**Re: Draft Final Remedial Design/Remedial Action Work Plan, LHAAP-03,
Former Waste Collection Pad, Building 722-P Paint Shop
Longhorn Army Ammunition Plant, Karnack, Texas, June 2019**

**Response to Comments on
Draft Remedial Design / Remedial Action Work Plan
LHAAP-03 Former Waste Collection Pad, Building 722-P Paint Shop,
Longhorn Army Ammunition Plant, Karnack, Texas**

Reviewer: Mr. Richard Mayer, USEPA

Reviewer: Ms. April Palmie, TCEQ

Figure 4-3
 Proposed Confirmation Samples
 1-Foot Excavation Areas
 LHAAP-03
 LONGHORN ARMY AMMUNITION PLANT
 KARNACK, TEXAS

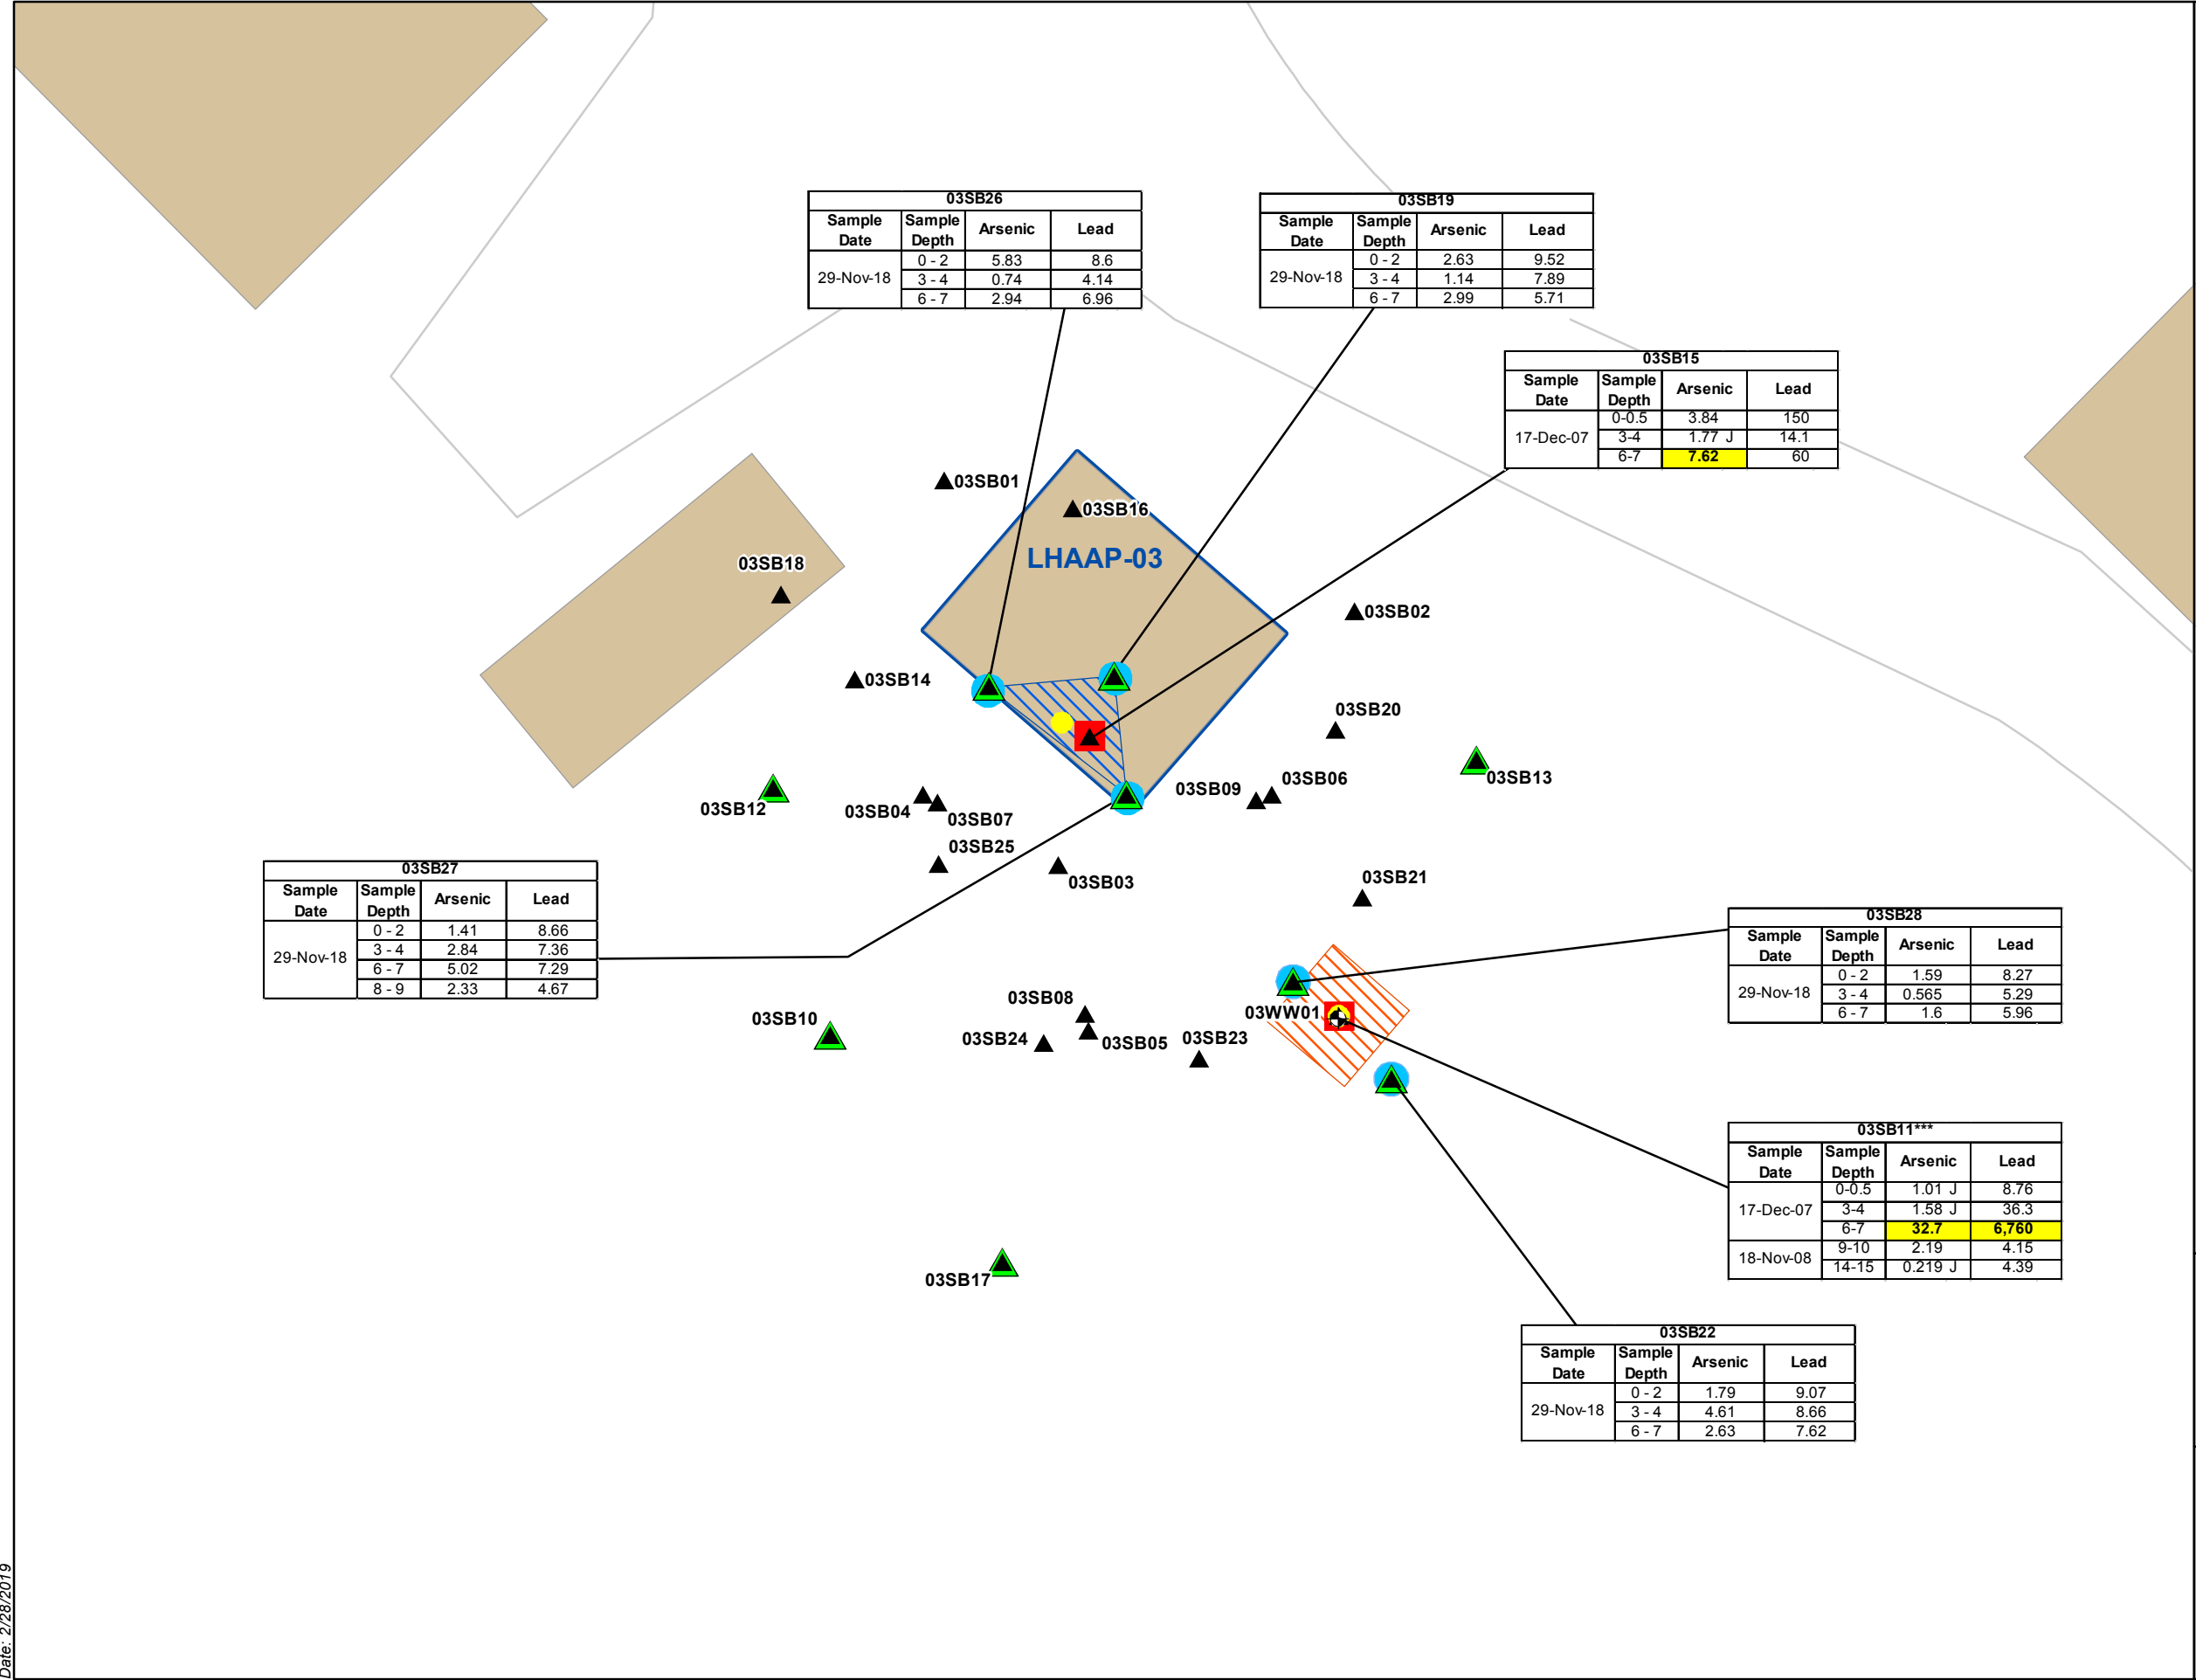
6.	Figure 4-3	Please revise the blue circle symbol description to “Existing SB results used as sidewall confirmation samples” [or similar] For notes 1 and 2 add reference to Table 4-1.	C	The description of the blue circle symbols has been revised to read “Existing soil boring sample to be used as a sidewall confirmation sample”. Reference to Table 4-1 has been added in parentheses in the 1 st and 2 nd notes.
